SUBDIVISION REVIEW SHEET**CASE NO.:** C8-2018-0039.0A**PC DATE:** March 12, 2019**SUBDIVISION NAME:** Stobaugh Resubdivision**AREA:** 1.16 acres**LOTS:** 6**APPLICANT:** Joseph Mueller**AGENT:** Civiltude, LLC (Eyad Kasemi)**ADDRESS OF SUBDIVISION:** 1200 Stobaugh**GRIDS:** MK29**COUNTY:** Travis**WATERSHED:** Waller Creek**JURISDICTION:** Full Purpose**EXISTING ZONING:** SF-3-NP**DISTRICT:** 7**LAND USE:** Residential**NEIGHBORHOOD PLAN:** Crestview**SIDEWALKS:** Sidewalks will be constructed along Stobaugh Street

**STOBAUGH RESUBDIVISION, A RESUBDIVISION OF
LOTS 12, 13 AND A PORTION OF LOT 11, BLOCK E
OF THE NORTHGATE ADDITION
City of Austin, Travis County, Texas**

Re: Letter of Submittal and Sufficient Existing Service
Stobaugh Subdivision Service Extension Request for Water (SER-4263)
1112, 1200, and 1202 Stobaugh Street, Austin, Texas, 78757

Re: Letter of Submittal and Sufficient Existing Service
Stobaugh Subdivision Service Extension Request for Wastewater (SER-4264)
1112, 1200, and 1202 Stobaugh Street, Austin, Texas, 78757

W.S.E.R. Name: Stobaugh Subdivision
W.S.E.R. Number: 4263

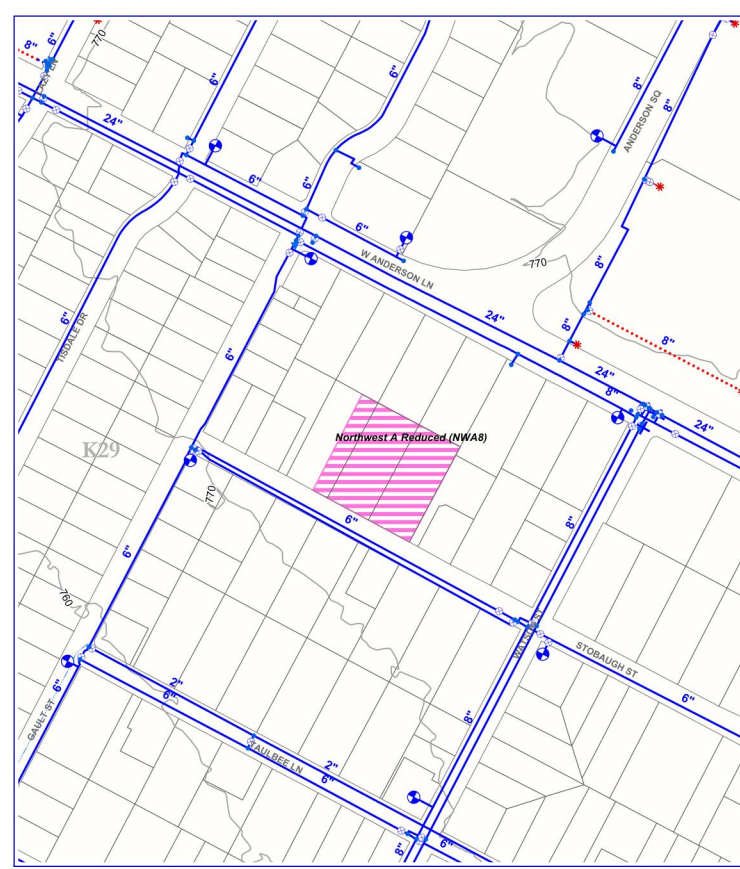
Based on the aforementioned project specifications and the results of the Service Extension Request review, it has been determined that the existing 6-inch water main at Stobaugh Street is suitable and sufficient to provide service to the subject tract.

Due to the existing suitable and sufficient water main at the subject tract, a water main extension/improvement is not required for this project.

W.W.S.E.R. Name: Stobaugh Subdivision
W.W.S.E.R. Number: 4264

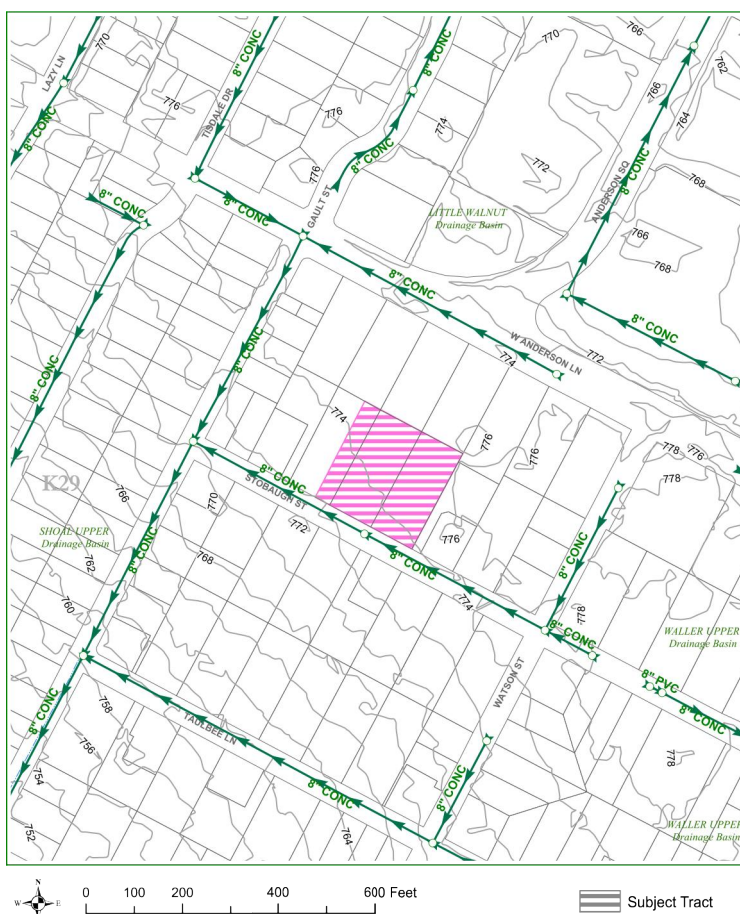
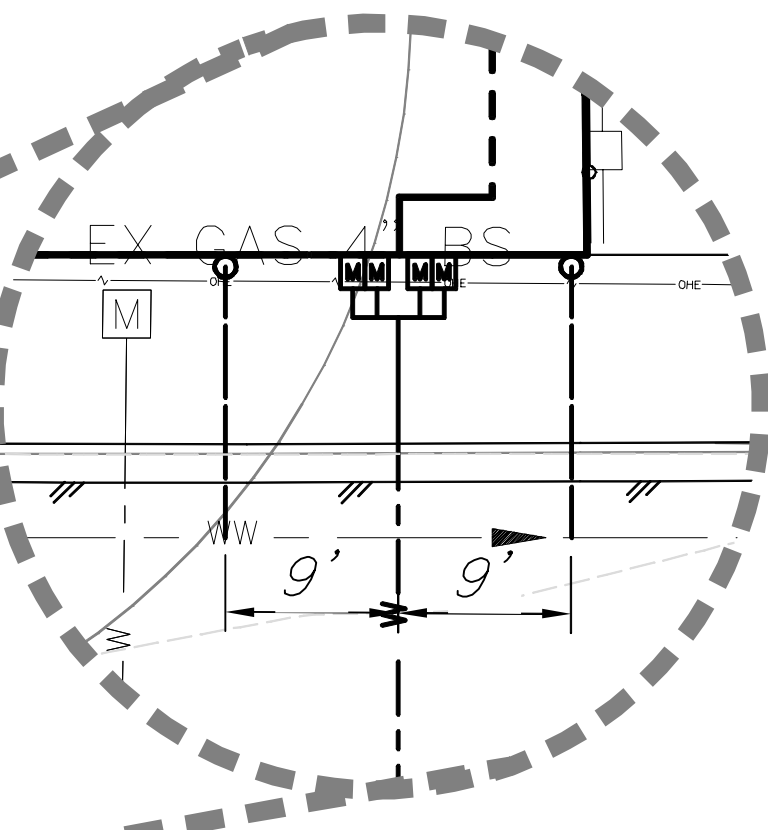
Based on the aforementioned project specifications and the results of the Service Extension Request review, it has been determined that the existing 8-inch gravity wastewater main at Stobaugh Street is suitable and sufficient to provide service to the subject tract.

Due to the existing suitable and sufficient gravity wastewater main at the subject tract, a wastewater main extension/improvement is not required for this project.

TAP CONCEPT PLAN DRIVEWAY & UTILITY PLAN

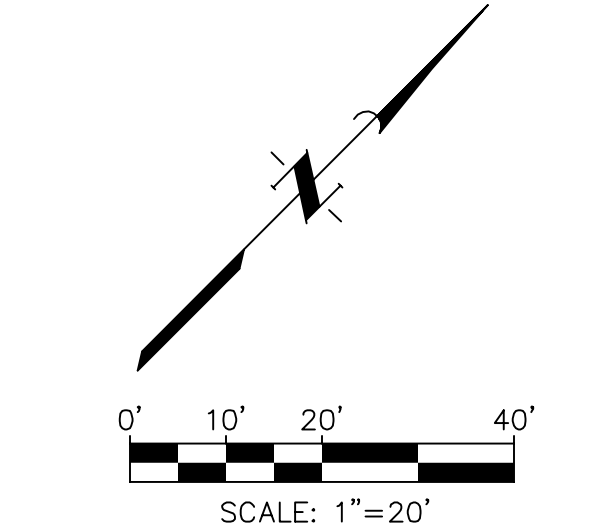
Subdivision review only - An engineered tap plan must be submitted to Austin Water for review and approval prior to obtaining a building permit
